8 November 2021  
Our Ref: 20768B.9DK\_s4.55\_1A\_Mod#2

**RE: SECTION 4.55(1A) APPLICATION TO MODIFY  
DEVELOPMENT CONSENT No. DA2020/0579 (AS MODIFIED)  
25-27 WARRIEWOOD ROAD, WARRIEWOOD**

Figure 1 Extract from architectural plan showing the location of design amendments

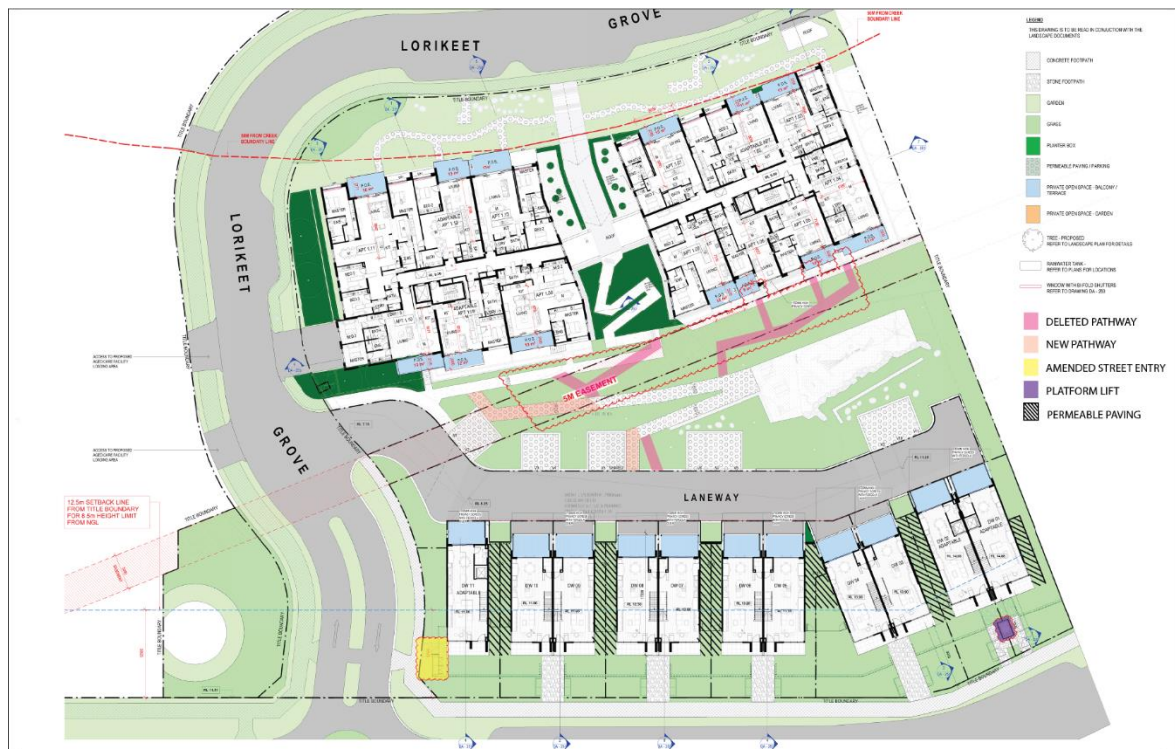
The proposed modifications are described below and the location of proposed design amendments are highlighted in **Figure 1**.

Sydney Water has been consulted during the preparation of construction certificate documentation as per Condition 32 of the consent. Sydney Water has advised that some of the 'hard' landscaping over the Sydney Water easement is to be relocated. This has resulted in the following design amendments which are represented in **Figure 1**

- The pathways providing individual pedestrian access to Apartments G.04, G.05 and G.06 have been removed. The fence line to the courtyards to these apartments has been moved to the top of the retaining wall in each courtyard and outside of the Sydney Water easement. The steps leading down into each courtyard have also been removed.
- The zig zag path leading from between the two apartment buildings has a small overlap within the Sydney Water easement. Connectivity is retained by using the approved path in front of Apartments G.07 and G.08 and a new connection is provided to the playground.
